WAILUA - KAPA'A  
NEIGHBORHOOD  
ASSOCIATION

October 27, 2014

RE: Coconut Beach Development LLC, Waipouli – Project Design Review (TMK 4-3-2:15, 16 and 20)  
SMA (U)-2006-4, PDU-2006-6, and Z-IV-2006-9

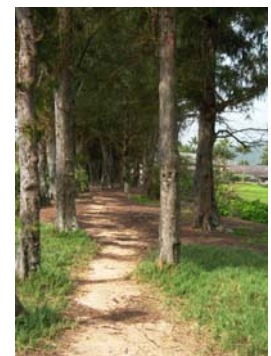
The project design affords minimal opportunity to retain important viewplanes to the ocean and mauka views of Nounou Mountain (the Sleeping Giant). Even the consulting architect admitted when describing the building mass, that several of the makai-to-mauka views were “challenged”.

This project proves how easy it is to avoid preservation of important coastal and mauka views, as shown in their Beach-Side and Street-Side perspective renderings. Considering guidelines in the General Plan and Coastal Zone Management Act guidelines to “protect, preserve, and where desirable, restore or improve the quality of coastal scenic and open space resources”, we would like the applicant to demonstrate improved compliance.

Think about why the Open District was designated along this stretch of coastline -- in part, it was to facilitate views. Nounou Mountain and the coastline are significant features in the landscape that provide a source of community pride and identity.
